Access Compliance Report

Public Rights-of-Way

(Curb Ramps)

Intersection ID: 46344	Main Street: BENNETT_NEELY_LN	Cross Street: STREAM_BANK_DR	Location: SE
ADA ID: E1A111AC2587	Ramp Type: Perp	Initial Pass/Fail: Pass	Overall Compliance: No
Codes/Mitigation Info/Possible Solution		Field Measurements/Component Compliance	
Severity Score: 10.25

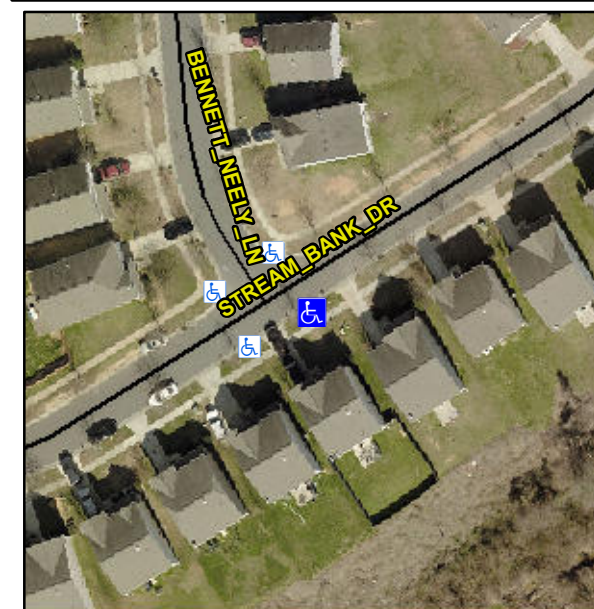
**Not Found, R304.5.3, R304.2.1,
R304.2.2-Perp, R304.3.2-Para, R305**

Compliance	Description	Data	Compliance	Description	Data
N/A	Ramp Length (in)	83.5	Yes	Ramp Slope (%)	5.2
Yes	Ramp Width (in)	48.0	No	Ramp XSlope (%)	2.6
N/A	Flare Type LT	Sloped	N/A	Flare Type RT	N/A
N/A	Flare Slope LT (%)	1.7	N/A	Flare Slope RT (%)	5.2
N/A	Flare Traversable LT?	No	N/A	Flare Traversable RT?	No
No	Landing Length (in)	47.0	No	DWS Provided?	No
Yes	Landing Width (in)	48.0	N/A	DWS Contrast?	No
No	Landing Slope (%)	2.2	N/A	DWS Length (in)	N/A
No	Landing X Slope (%)	2.8	N/A	DWS Full Width?	No
N/A	Landing Curb? (Y/N)	No	N/A	DWS Offset (in)	N/A
N/A	Shared Landing?	No			
Yes	Gutter Ponding?	No	Yes	Gutter Slope (%)	4.9
Yes	Gutter Lip Ht (in)	0.0	No	Gutter X Slope (%)	2.6
N/A	Painted X Walk1?	No	N/A	Painted X Walk2?	N/A
	X Walk 1 Direction	To NW		X Walk 2 Direction	N/A
N/A	X Walk 1 Width (in)	N/A	N/A	X Walk 2 Width (in)	N/A
	X Walk 1 Slope (%)	2.4		X Walk 2 Slope (%)	N/A
	X Walk 1 X Slope (%)	2.2		X Walk 2 X Slope (%)	N/A

N/A	Ramp inside XWalk1?	N/A	N/A	Ramp inside XWalk2?	N/A
	Road Slope (%)	N/A	N/A	Clear Space?	Yes
	Road X Slope (%)	N/A	N/A	Clear Space to XWalk (in)	N/A
Yes	Any Obstructions?	No	Yes	Storm Grate/Utility Hazard?	No
	Obstruction Type			Storm Grate/Utility Type	
		N/A			N/A
			Yes	Surface Condition? (G/P)	Good

**Remove & Replace Entire Ramp.
Remove & Replace Gutter.**
